an application for approvals by Matakanui Gold Limited to establish, operate, rehabilitate and ultimately close an open pit and underground gold mining operation known as the Bendigo-Ophir Gold Project

**STATEMENT OF EVIDENCE OF LAUREN WINDROSS**

## **Proposed Bendigo-Ophir Mine**

### **Environmental Effects Review: Arsenic**

**Figure 6. Arsenic values >70ppm (image source: Matakanui). Refer below for full size version. Annotations by WWLA**

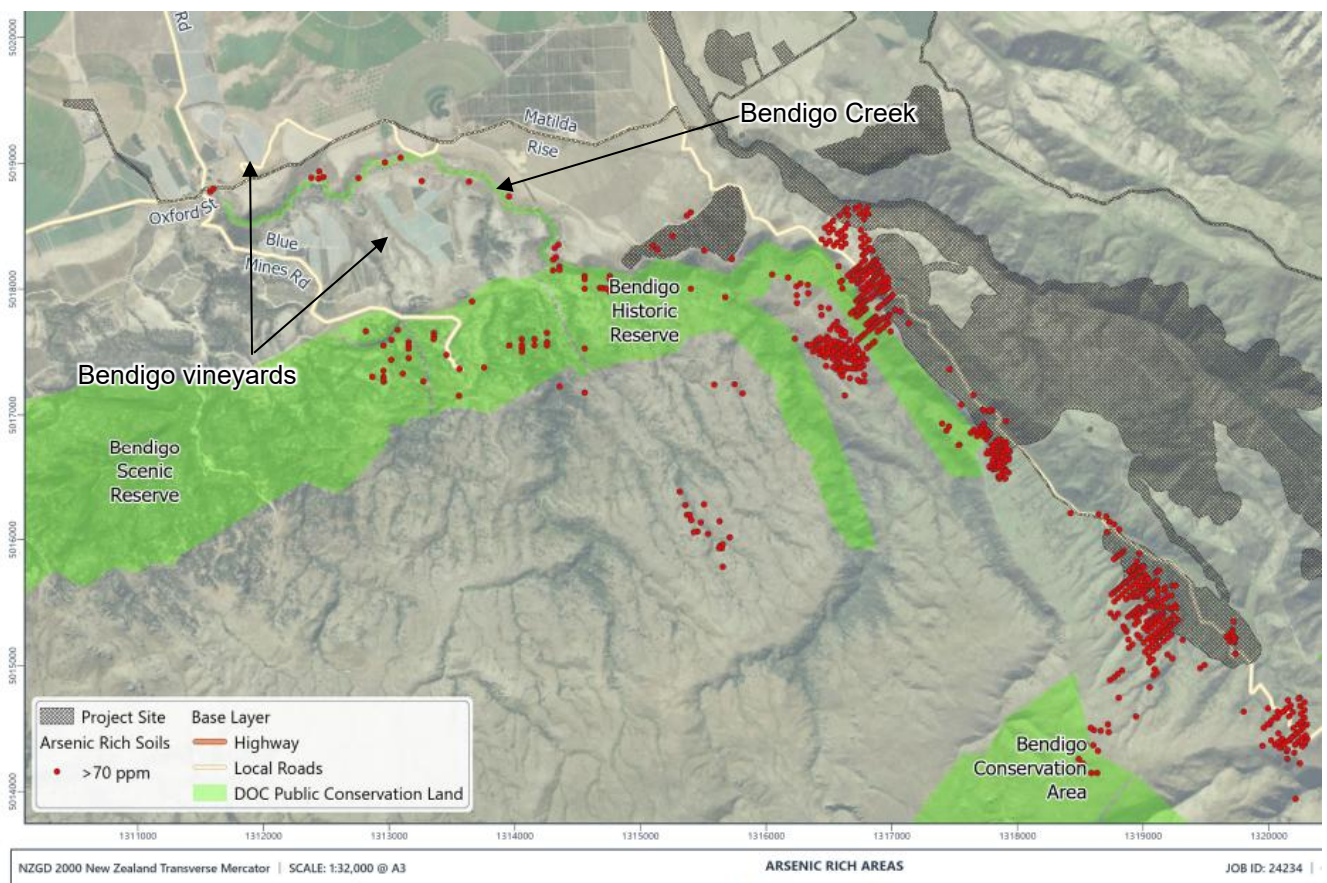
The map is shown in **Figure 6** below and shows that arsenic concentrations are elevated above 70 ppm in the immediate vicinity of known ore bodies, with sporadic elevated readings elsewhere. There is a trend of elevated arsenic through the Bendigo Creek, indicated below, *potentially due to migration of arsenic-rich sediments from further up the catchment.*

Figure 7. Arsenic concentrations in the vicinity of the Bendigo vineyards (image source: Matakauui/ Santana). Annotations by WWLA

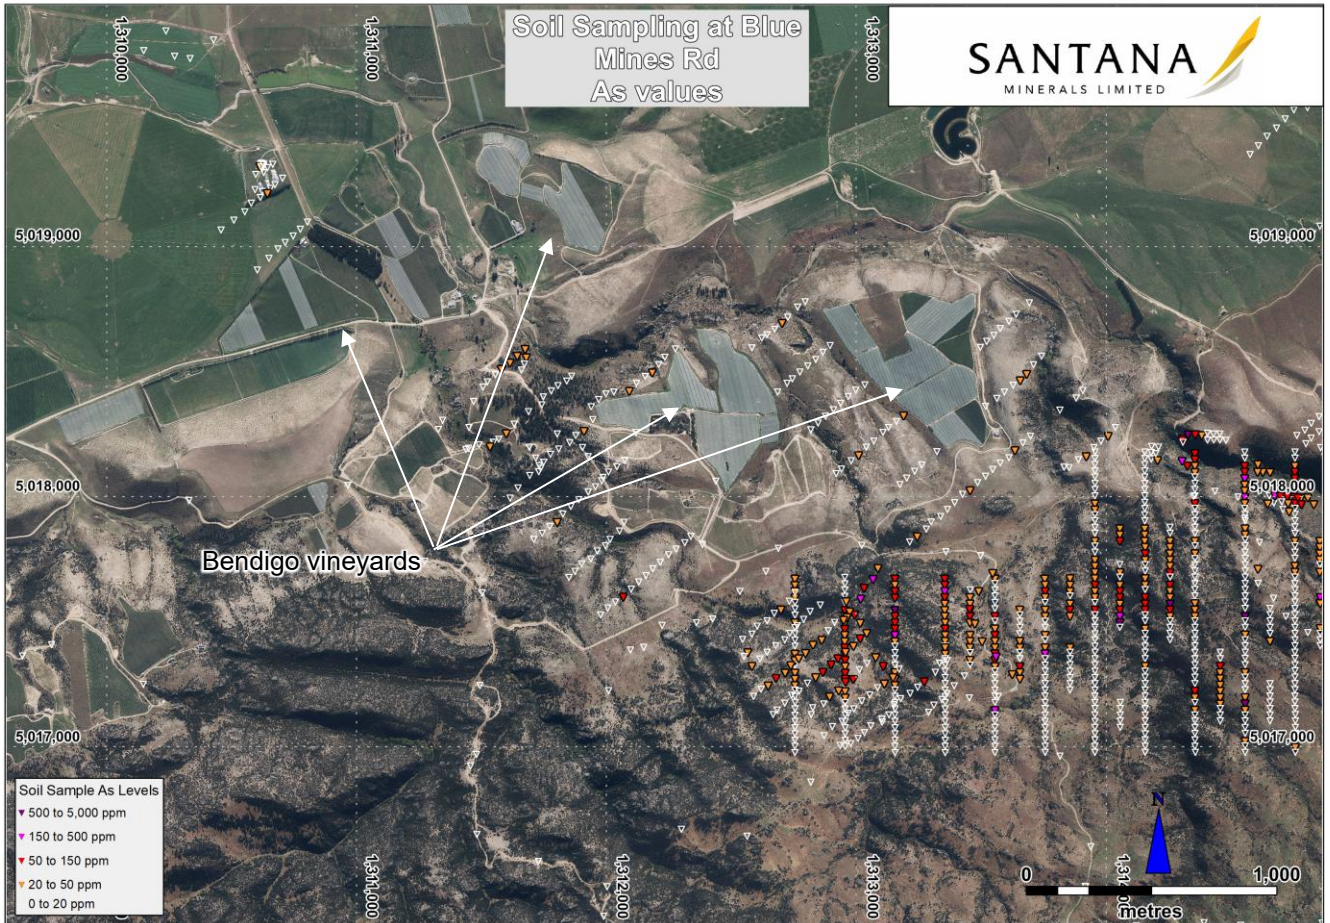
*The arsenic data presented is typical of what would be expected in a mineralised area, with concentrations being significantly elevated above “typical” background concentrations in mineralised areas. Sporadic exceedances may be associated with alternative anthropogenic sources (such as old sheep dips or mine workings) and there is likely to have been some natural migration of arsenic along surface water features. The*

data also indicates that the vineyards themselves are likely to have relatively low arsenic concentrations; refer to **Section 4** for further information.

**Figure 9. Surface water and groundwater compliance monitoring sites. Extracted from Figure 13 of application document G.01.**

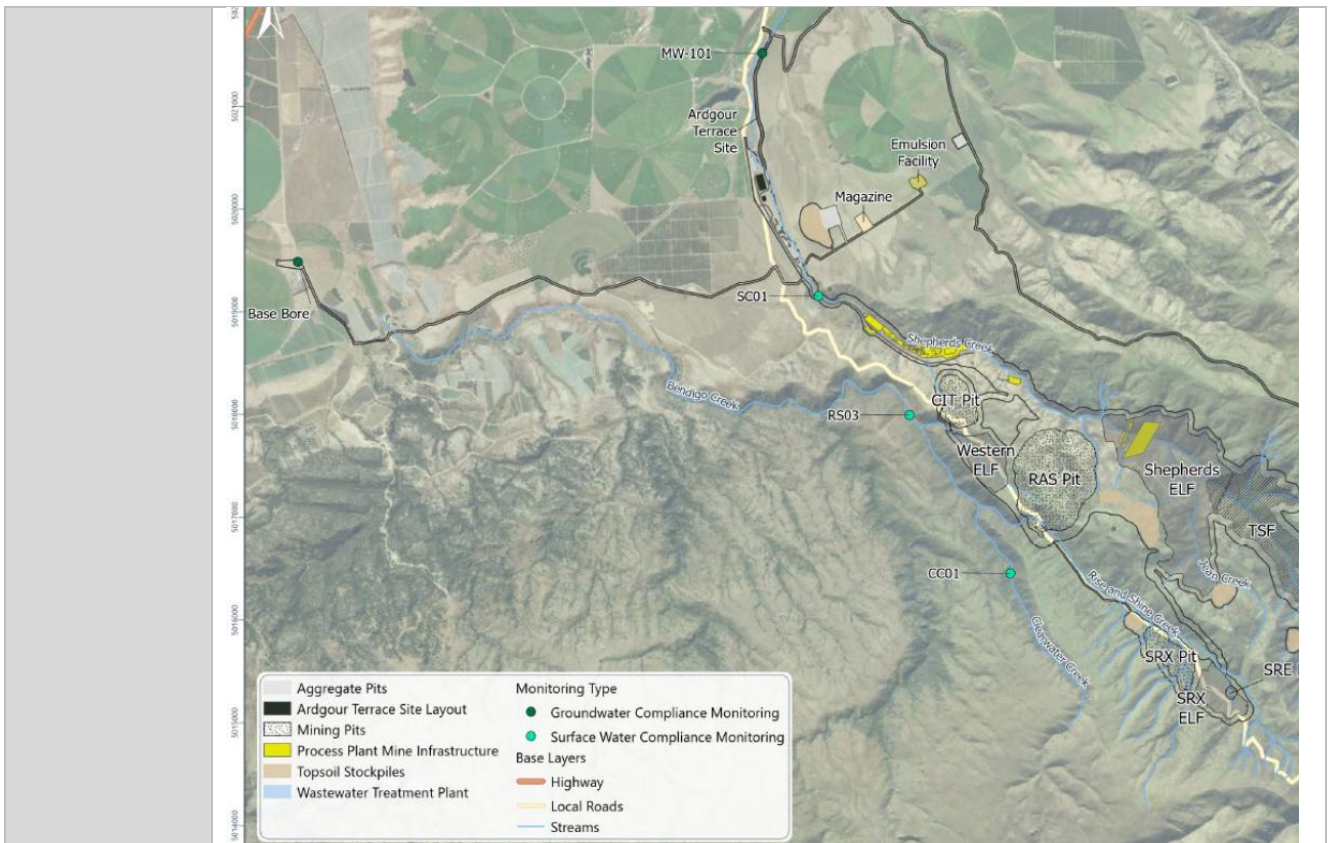
*WWLA's comments with respect to the arsenic compliance limit for both groundwater and surface water are as above for the Water Management Plan. Further, the assessment considers only the arsenic concentrations in Rise and Shine Creek, and not that of Shepherd's Creek, which has significantly less arsenic already present (Document 10, Section 3).*
